EAST TOWN CROSSING FRONTAGE IMPROVEMENTS

COVER SHEET

EAST TOWN CROSSING SHAW ROAD IMPROVEMENTS

2 CARTRIDGE CATCHBASIN STORMFILTER STANDARD DETAIL

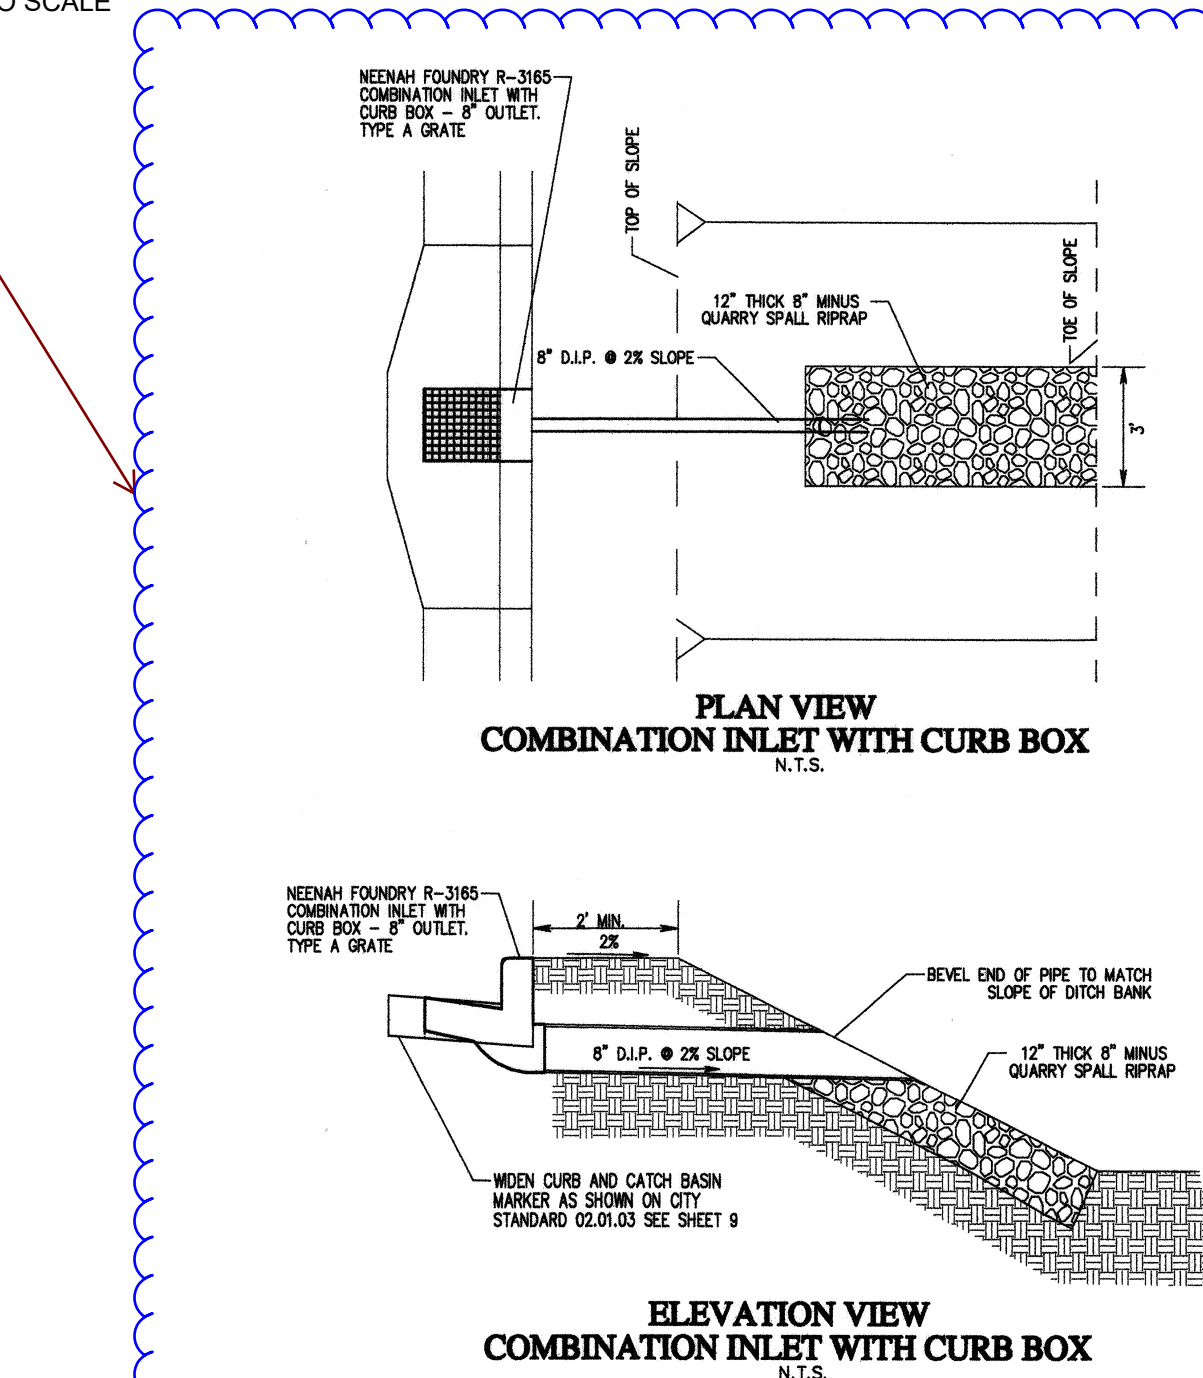
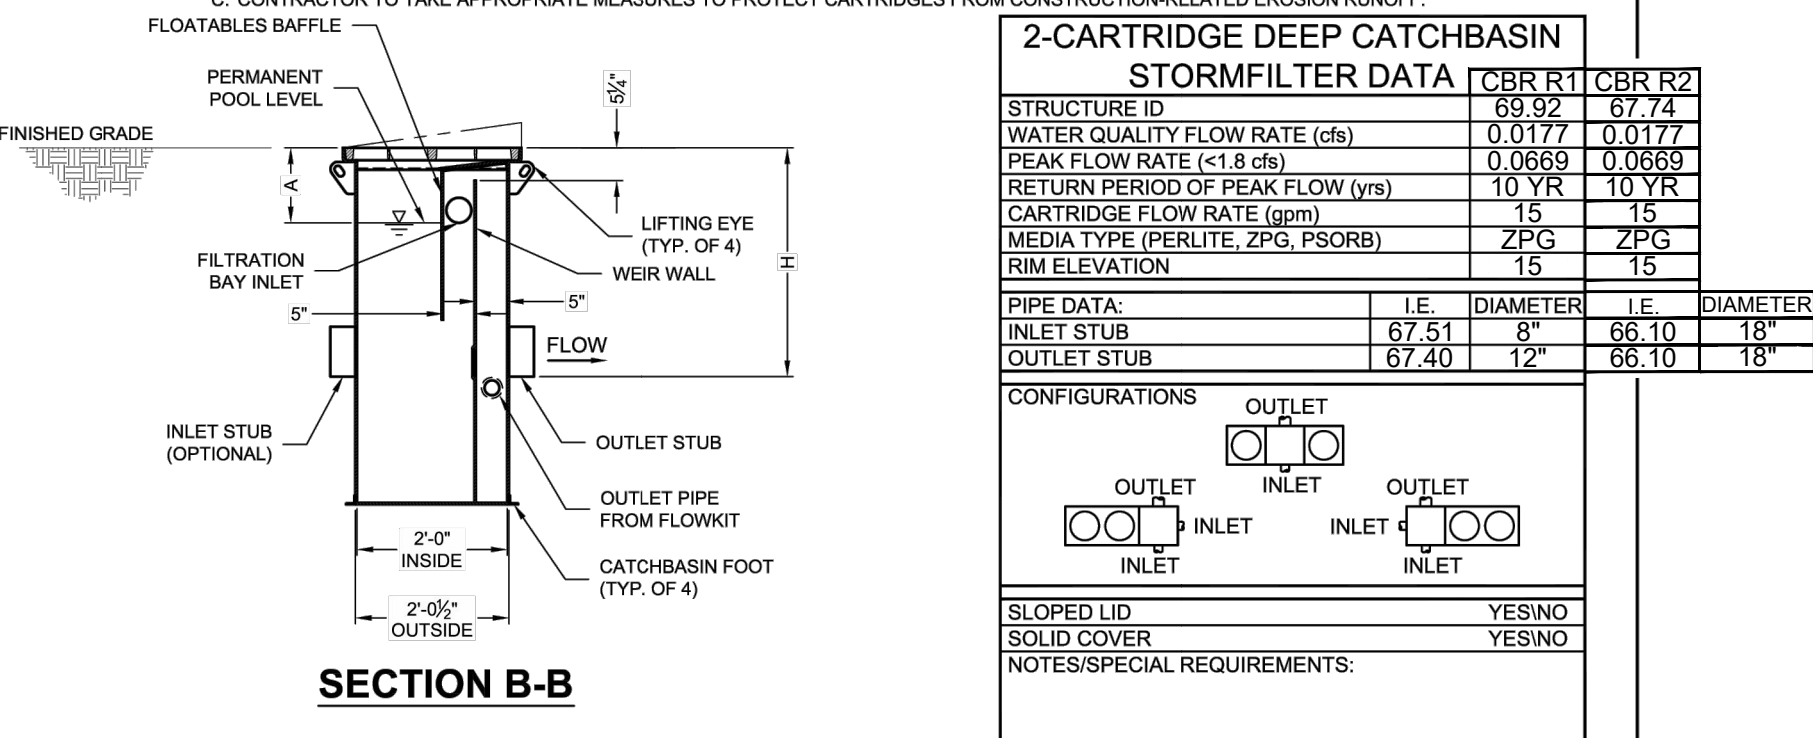
Due to the configuration of the Contech Stormfilter CB, the location of the outlet places the CB perpendicular to the curbline and into the travel lane. City Standards 204.8(11) does not allow solid square lids in the travel lane. Either replace the proprietary square lid with round lids or provide an alternative device (see Old Castle Perk Filter as an example). [Plans; Sht R6.2 of 21]
